**Checks for Calculation No: NSTXU-CALC-11-29-00**

***Title: OBD12 Hold Down Submodel***

# Simplified Analysis of Tile Hold Down Rods

Figure 1. Minimum Principal Stress, PDR analysis. Material is Sigratine SGLR6510; allowable S3 is -65MPa

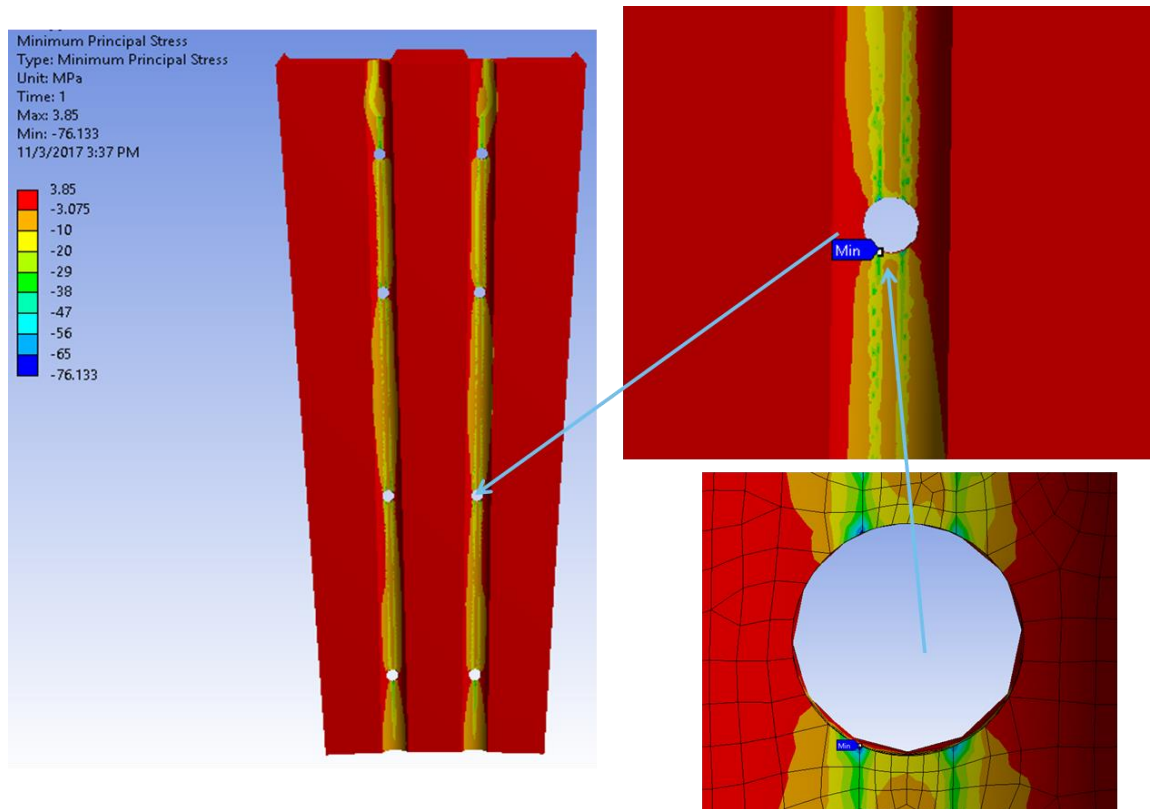
Stress analyses of the OBD Row 1-2 tiles presented at the November 2017 Preliminary Design Review showed high contact stresses where the hold-down rods cross the holes for their #8-32 screws. (Figure 1) These stresses can be reduced by thinning the rods where they cross over the screw holes, thus shifting the contact area away from the edge of the hole.

Figure 5. Major Principal Stress

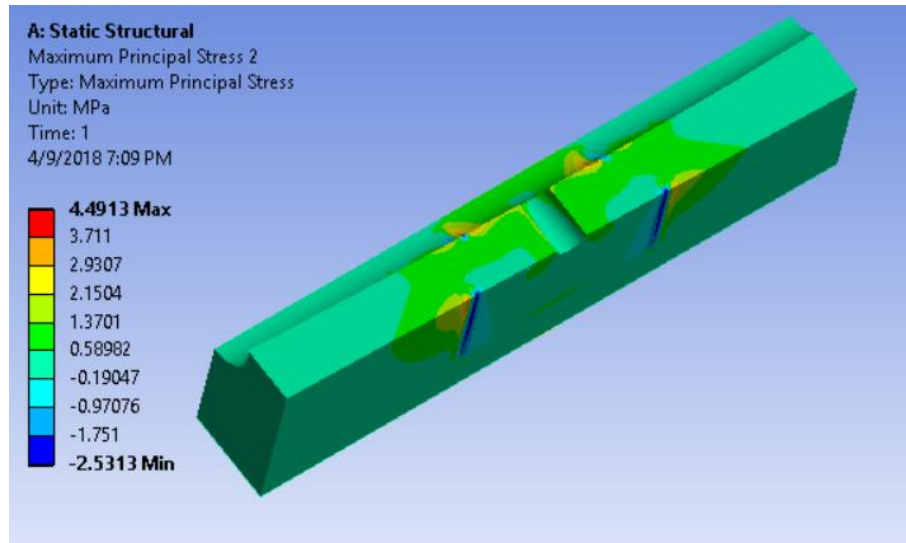
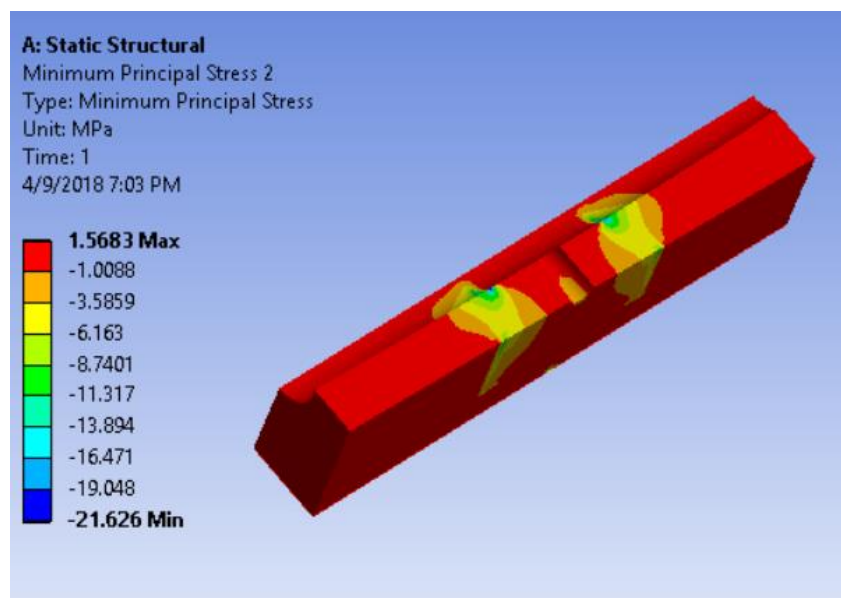
Figures 5 and 6 show the major and minor principal stresses within their allowable ranges. The analysis shows that the contact point can be moved closer to the screw hole, from .375 inches to .250 inches. Figure 7 shows displacement contours for the rod and the block.
